Application No.: 10/007,204  
Amdt. Dated April 23, 2004  
Reply to Office Action of November 25, 2003

Application No.: 10/007/204  
Amdt. Dated April 23, 2004  
Reply to Office Action of November 25, 2003  
Annotaed Sheet Showing Changes

FIG. 3A

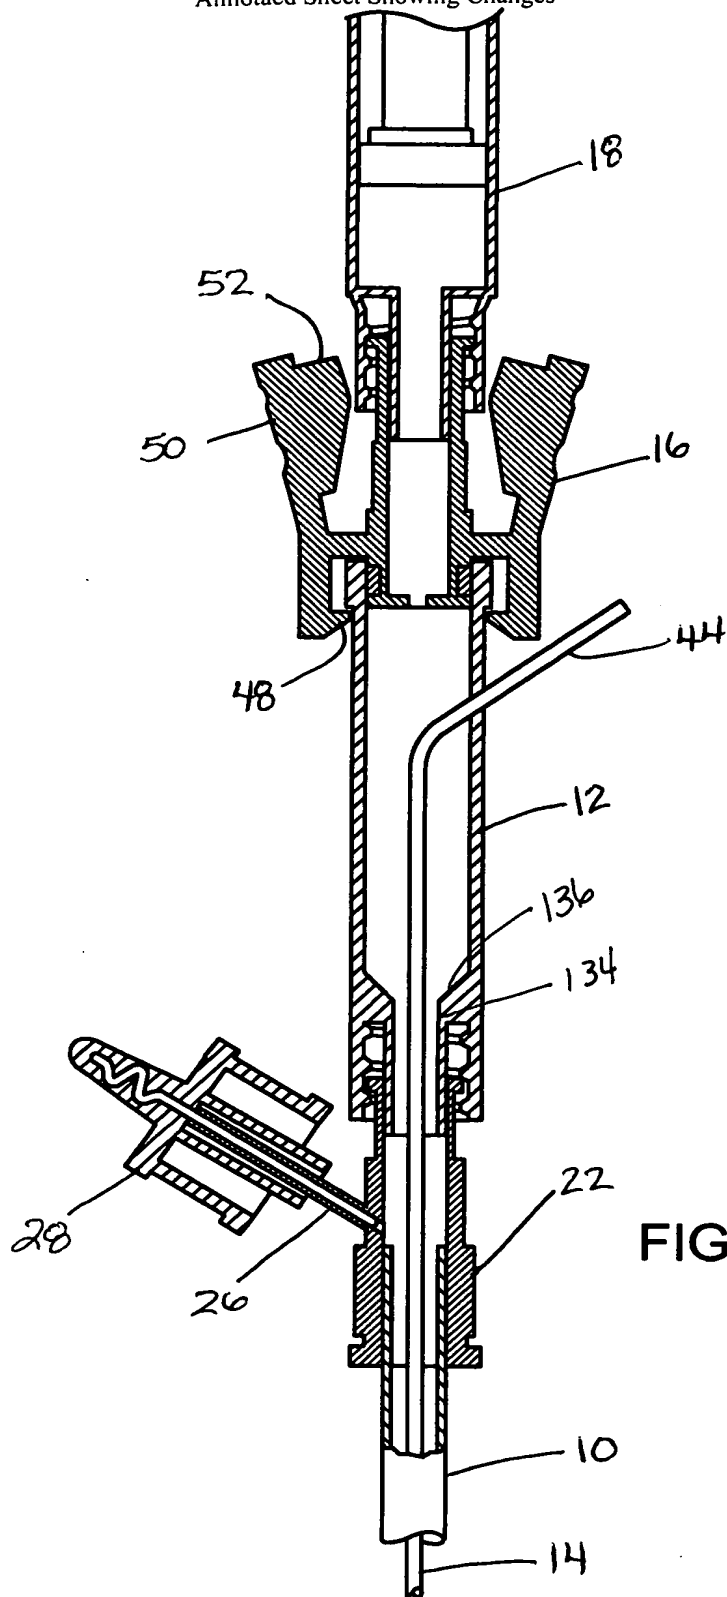
The proposed drawing correction filed on June 9, 2003 was not approved. Specifically, the office action states that the "drawings are objected to under 37 CFR 1.83(a). The drawings must show every feature of the invention specified in the claims. Therefore, the features of claims 5 and 6, wherein the hydration chamber has a tapered portion in between two larger portions, must be shown or the feature(s) canceled from the claim(s). No new matter should be entered. Since this subject matter is described in the original disclosure, applicant may submit drawings showing this feature." This objection is respectfully traversed.

Figs. 3A, 3B, 3C, and 3D have been amended to include the features of Claims 5 and 6. However, it is pointed out that these features are also included in other figures such as Fig. 6, among others.

The specification is objected to as allegedly “failing to provide proper antecedent basis for the claimed subject matter.” The office action states that there “does not appear to be a description of claims 5 and 6 in the specification or the drawings. However, since this subject matter was described in the original claims, applicant should submit an amendment to the specification and additional drawings.” Applicant respectfully traverses this objection.

Thus, it is respectfully requested that this objection be withdrawn and the amendments to Figs. 11 and 3A-3D be approved and entered.
